<b>Subject:</b> Replacing Throttle Pedal Jumper Harness			
<b>Field Change Program:</b> Field Campaign	<b>FCP Number:</b> 475	<b>Revision:</b> A	<b>Date:</b> 03/24/2020
<b>Coach Section:</b> 07- Electrical	<b>P/N:</b> 04-15-1282		<b>Type:</b> Product Integrity

## 1.0 Description

Accelerator Position Sensor

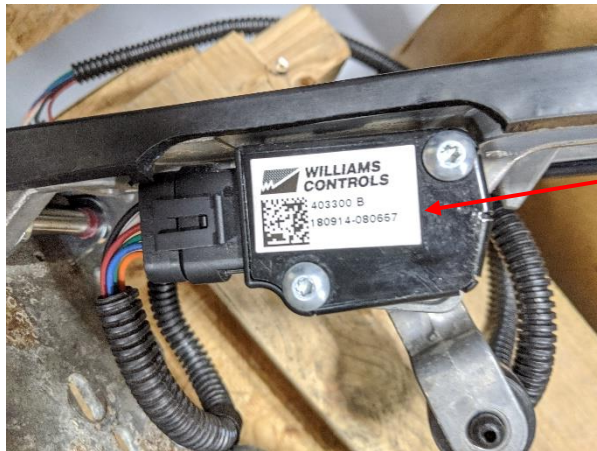
Connect the assembled 6-pin end of the throttle pedal jumper harness to the accelerator position sensor on the throttle pedal.

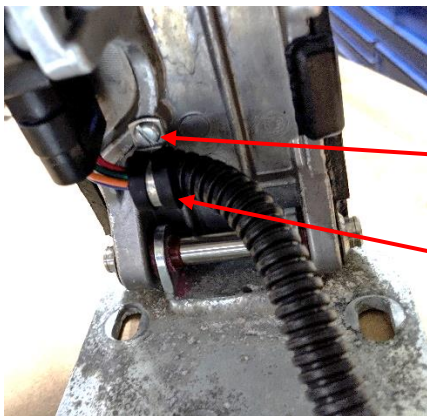
Using self-tapping screw, part of kit T07-3774, install p-clamp, part of kit T07-3774, to the throttle pedal as shown below.

Re-install the existing p-clamp removed earlier as shown below.

Harness routing

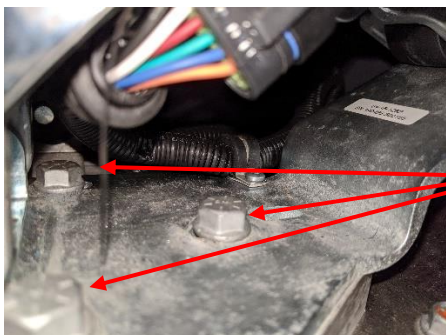
Make sure you route the jumper harness between the p-clamps leaving enough slack as shown in the picture below.
